Planning application 09/02175/FUL

*26 Lathbury Road*

Tree constraints plan

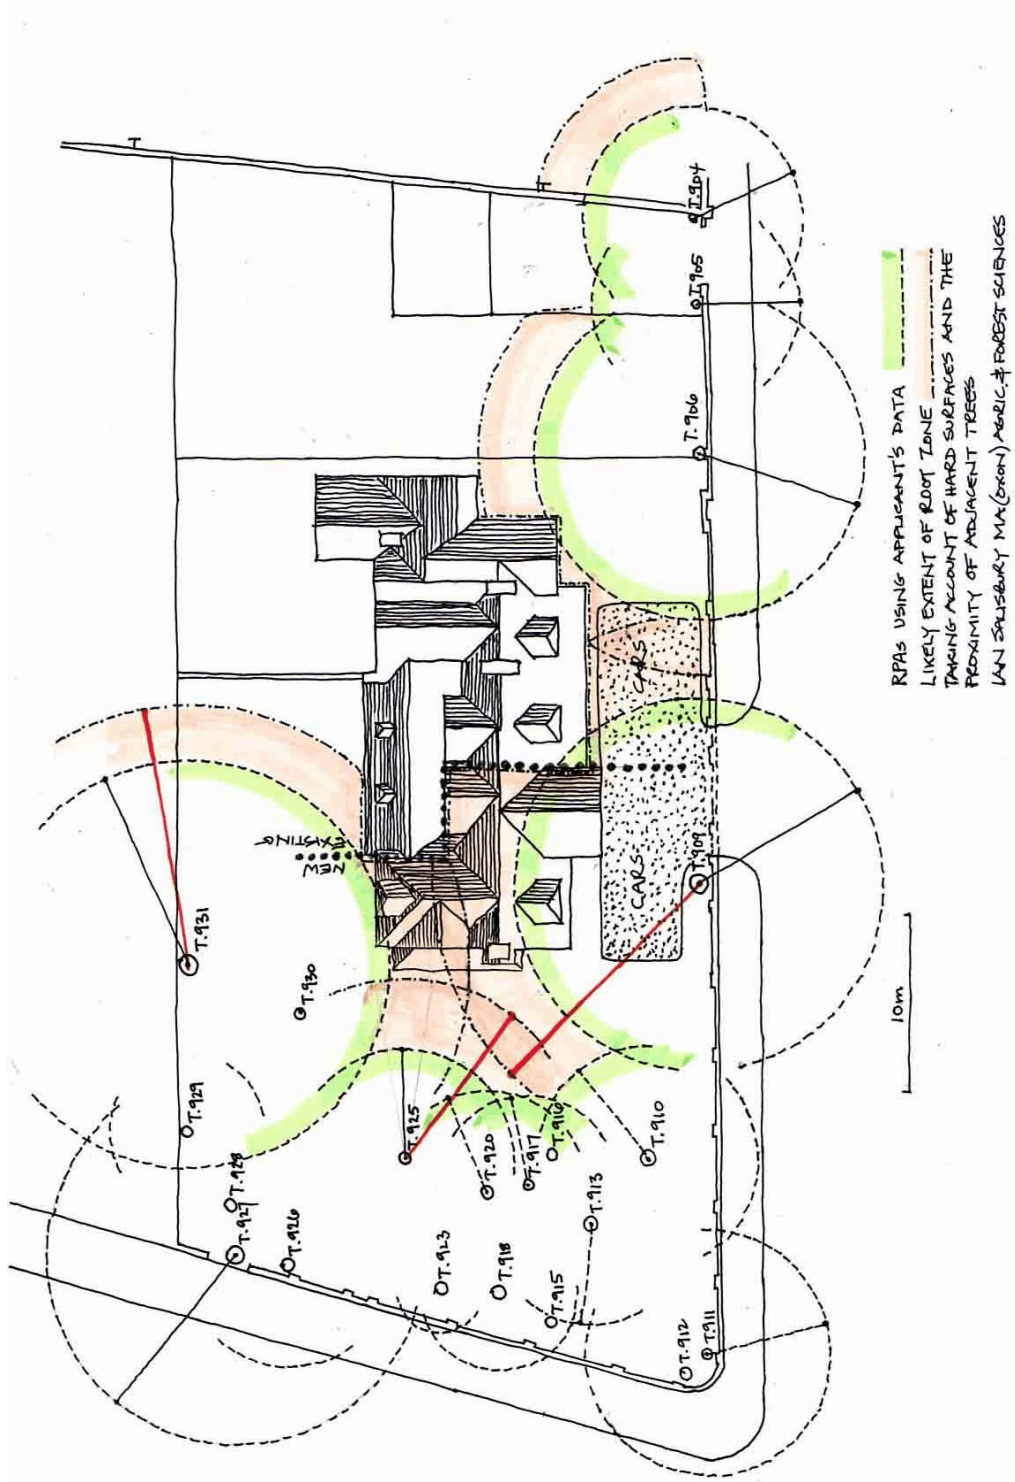
Overleaf is a Tree Constraints Plan. In green, the RPA for each significant tree has been plotted using the applicant's consultant's data. However, these RPAs are shown as being circular irrespective of the likely morphology and disposition of the roots, taking into account other trees, roads, structures and underground services. It should be noted that in the submitted tables of data, the units for the "stem diameter" used are centimetres and not millimetres, and the last column does not show the RPA but the radius of the RPA, as if the actual RPA could be a circle centred upon the trunk. This cannot be in such a place as this where trees are crowded, where there are hard impervious surfaces, and where there are existing foundations.

In fact, none of these trees can be considered to be "open grown" within the meaning of the British Standard. The oak tree T.909 has 50% of its potential root area covered with tarmac, and in consequence the fibrous roots will reach out further to where there is open ground to the north. As will be noticed, this includes most of the ground that it is intended to build upon. T.925, the horse chestnut (that was overlooked in the application drawings) is likely to be in competition for moisture from both the oak and the beech T.931, and it is not surprising that during the late summer, this was one of the first horse chestnuts in the area to show stress and damage caused by the leaf miner *Cameraria ohridella*.

With the incidence of bleeding canker now sharply increasing, stressed horse chestnuts such as this tree must be considered to be already at risk from this fungus. Any further stress is likely to increase the incidence of this pathogen, and endanger the tree. T.931, the large beech tree, is also not "open grown", for not only are there large trees to the west of it, but there are also trees to the north and west in the adjoining garden of 136 Woodstock Road, which the applicant has not shown. These trees will drive the fibrous roots of the beech south and east, as shown on the plan. In fact it will be seen from this plan how important the present open space of the garden will be for the nurture and watering of these trees.

In the memorandum, Mr Crofton-Briggs properly mentions services, and for this reason I have included in the tree constraint plan the RPA of the trees at the eastern end of the plot. This shows that there is no area that is now free of the root zone that would be available for excavation.
